Access Compliance Report

Public Rights-of-Way

(Curb Ramps)

Intersection ID: 48580	Main Street: SWEET_FLAG_CT	Cross Street: RUMPLE_RD	Location:	N
ADA ID: 14EF8C13ACF5	Ramp Type: BlendTrans1	Initial Pass/Fail: Fail	Overall Compliance: No	Severity Score: 25

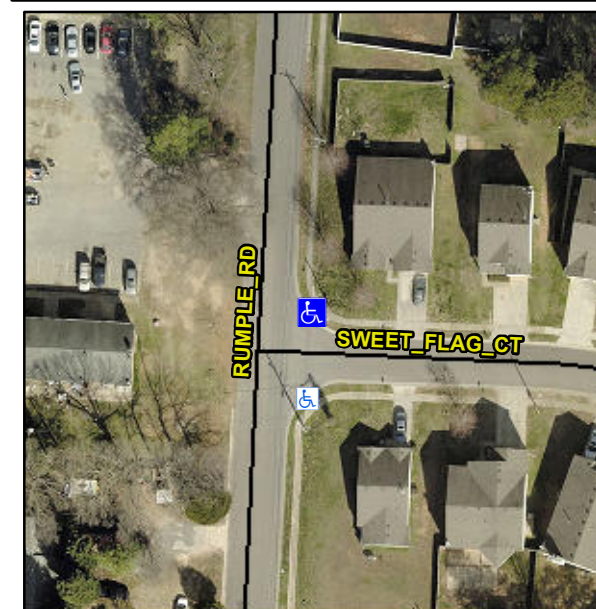
Not Found, R304.5.3

Compliance	Description	Data	Compliance	Description	Data
N/A	Ramp Length (in)	48.0	Yes	BlendTrans Slope (%)	4.4
Yes	Ramp Width (in)	48.0	No	BlendTrans XSlope (%)	8.1
N/A	Flare Type LT	N/A	N/A	Flare Type RT	N/A
N/A	Flare Slope LT (%)	N/A	N/A	Flare Slope RT (%)	N/A
N/A	Flare Traversable LT?	N/A	N/A	Flare Traversable RT?	N/A
N/A	Landing Length (in)	N/A	N/A	DWS Provided?	N/A
N/A	Landing Width (in)	N/A	N/A	DWS Contrast?	N/A
N/A	Landing Slope (%)	N/A	N/A	DWS Length (in)	N/A
N/A	Landing X Slope (%)	N/A	N/A	DWS Full Width?	N/A
N/A	Landing Curb? (Y/N)	N/A	N/A	DWS Offset (in)	N/A
N/A	Shared Landing?	N/A			
N/A	Gutter Ponding?	N/A	N/A	Gutter Slope (%)	N/A
N/A	Gutter Lip Ht (in)	N/A	N/A	Gutter X Slope (%)	N/A
N/A	Painted X Walk1?	No	N/A	Painted X Walk2?	N/A
	X Walk 1 Direction	To S		X Walk 2 Direction	N/A
	X Walk 1 Width (in)	N/A		X Walk 2 Width (in)	N/A
	X Walk 1 Slope (%)	5.0		X Walk 2 Slope (%)	N/A
	X Walk 1 X Slope (%)	7.2		X Walk 2 X Slope (%)	N/A

N/A	Ramp inside XWalk1?	N/A	N/A	Ramp inside XWalk2?	N/A
	Road Slope (%)	7.2		Clear Space?	N/A
	Road X Slope (%)	5.0	N/A	Clear Space to XWalk (in)	N/A
N/A	Any Obstructions?	N/A	N/A	Storm Grate/Utility Hazard?	N/A
	Obstruction Type			Storm Grate/Utility Type	
		N/A			N/A
			Yes	Surface Condition? (G/P)	Good
			No	Curb Slope (%)	20.3

Remove & Replace Curb Ramp With Two New Directional Ramps or Equivalent.
